The Commission has issued the enclosed Amendments No. 26 to Facility Operating Licenses Nos. DPR-32 and DPR-37 for the Surry Power Station Units Nos. 1 and 2. The amendments consist of an added condition to the license for Surry Unit No. 2 and changes to the Technical Specifications in partial response to your application dated September 27, 1976, as supplemented October 29, 1976, and your submittals dated October 19, 1976, and November 15, 1976. We did not include any revisions in your Technical Specifications related to the Nuclear Enthalpy Rise Hot Channel Factor (F<sub>NH</sub>); hence, you should continue to operate Surry Unit No. 2 under the existing Technical Specifications for F<sub>NH</sub> and the additional restrictions of your August 18, 1976 letter (Serial No. 194).

VIRGINIA ELECTRIC & POWER COMPANY

Amendment No. 26  
License No. DPR-32

ATTACHMENT TO LICENSE AMENDMENT NO. 26

HOT CHANNEL FACTOR NORMALIZED  
OPERATING ENVELOPE

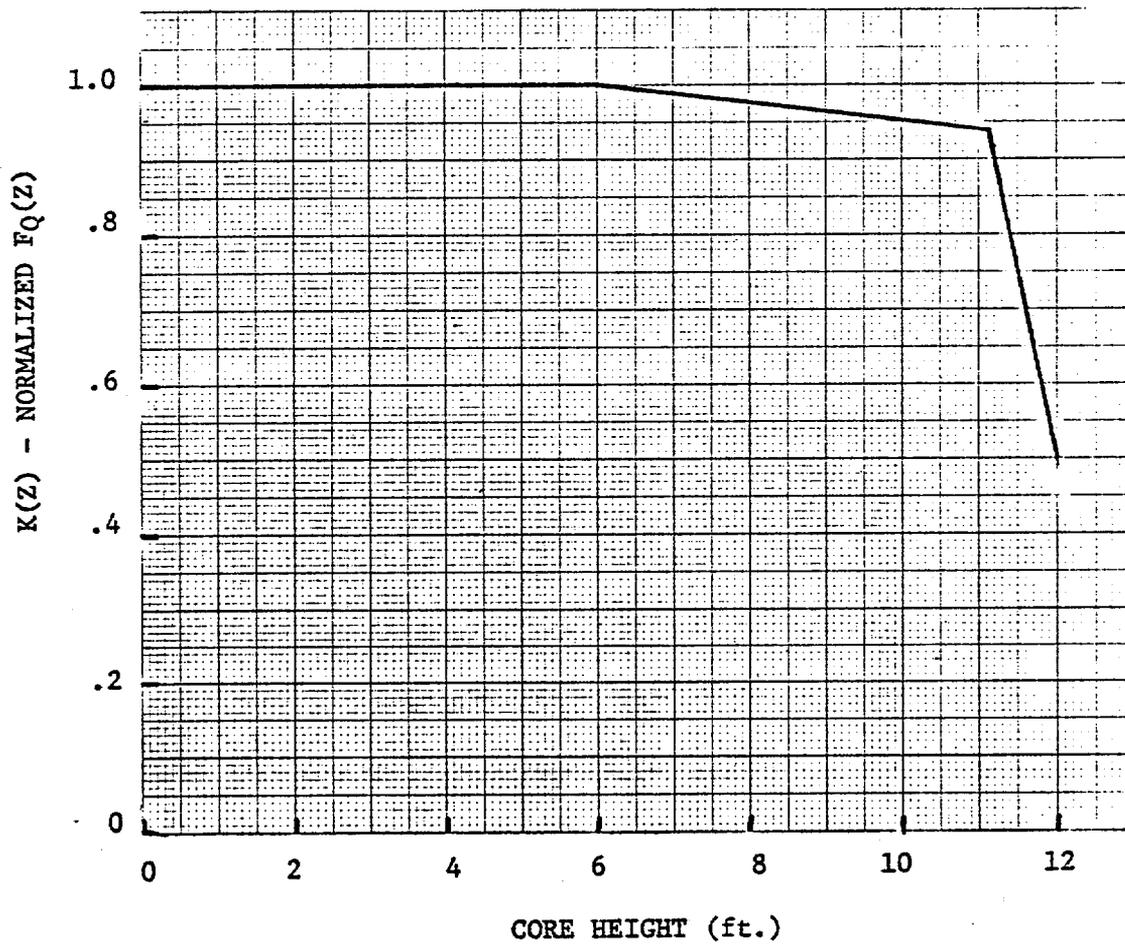
where P is the fraction of rated power at which the core is operating, K(Z) is the function given in Figure 3.12-8, Z is the core height location of F<sub>Q</sub>.

The results of the loss of coolant accident analyses are conservative with respect to the ECCS acceptance criteria as specified in 10 CFR 50.46 using an upper bound envelope of 2.00 times the hot channel factor normalized operating envelope of TS Figure 3.12-8.

HOT CHANNEL FACTOR NORMALIZED  
OPERATING ENVELOPE

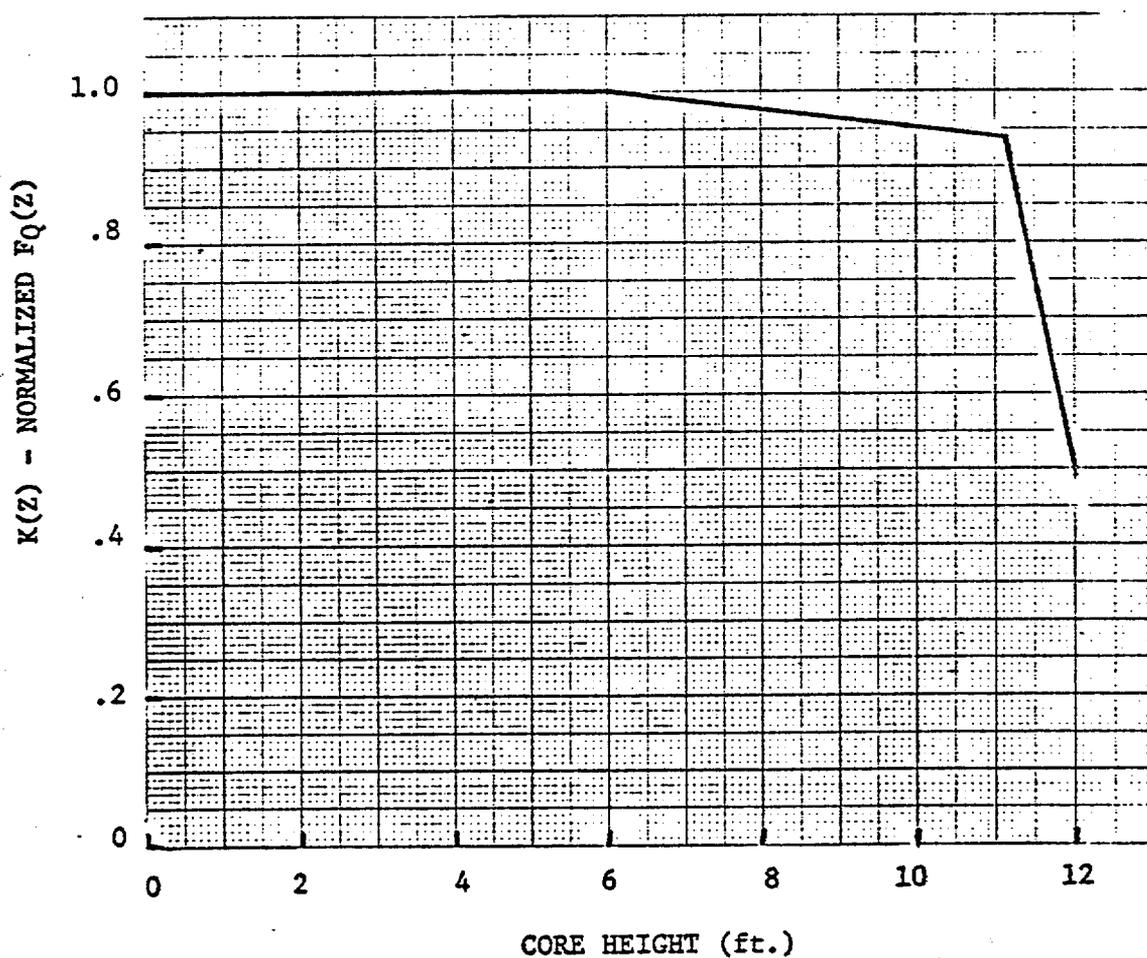
where P is the fraction of rated power at which the core is operating, K(Z) is the function given in Figure 3.12-8, Z is the core height location of F<sub>Q</sub>,

The results of the loss of coolant accident analyses are conservative with respect to the ECCS acceptance criteria as specified in 10 CFR 50.46 using an upper bound envelope of 2.00 times the hot channel factor normalized operating envelope of TS Figure 3.12-8.
